HISTORIC AND DESIGN REVIEW COMMISSION August 16, 2017

HDRC CASE NO: 2017-421 **ADDRESS:** 1115 E CROCKETT ST NCB 578 BLK D LOT E 34.3 FT OF 5 ARB A-8 **LEGAL DESCRIPTION: ZONING: RM-4**. H **CITY COUNCIL DIST.:** 2 **DISTRICT: Dignowity Hill Historic District** Felix Ziga/Ziga Architecture Studio **APPLICANT:** Henneke Financial Group, LLC **OWNER:** Construction of a rear carport **TYPE OF WORK:**

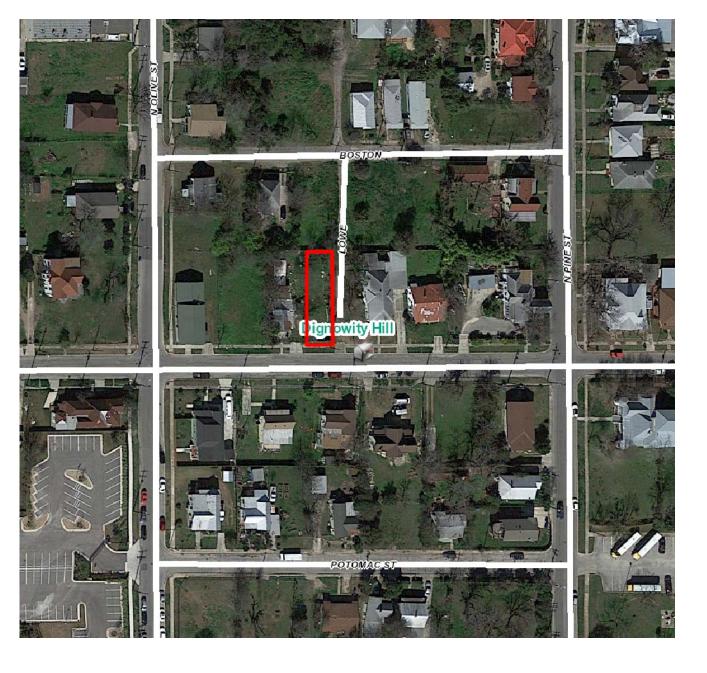
- a. The applicant has proposed to construct an open air carport at 1115 E Crockett, located within the Dignowity Hill Historic District. The proposed carport will be located at the rear of the previously approved new construction.

- b. CARPORT The Guidelines for New Construction 5.A. note that new accessory structures should be visually subordinate to the principal historic structure on the lot in terms of their height, massing and form, should be no larger in plan than forty percent of the historic structure's footprint and should relate to the period of construction of the primary historic structure on the lot through the use of complementary materials and simplified architectural details. The applicant has proposed a footprint of approximately 400 square feet and has proposed materials to include metal columns and a standing seam metal roof. Given its location within the Dignowity Hill Historic District, staff finds the installation of wood materials, rather than metal to be appropriate.

- c. CARPORT The Guidelines for New Construction 5.B. note that the predominant orientation for accessory structures should be used. The applicant has proposed to locate the accessory structure adjacent to the side alley, which will provide access to the structure. Additionally, the applicant has proposed a location that is consistent with the location of historic accessory structures throughout the district. Staff finds the proposed location to be appropriate.

Staff recommends approval based on findings a through c with the stipulation that the applicant use wood columns and beams in place of the proposed metal.
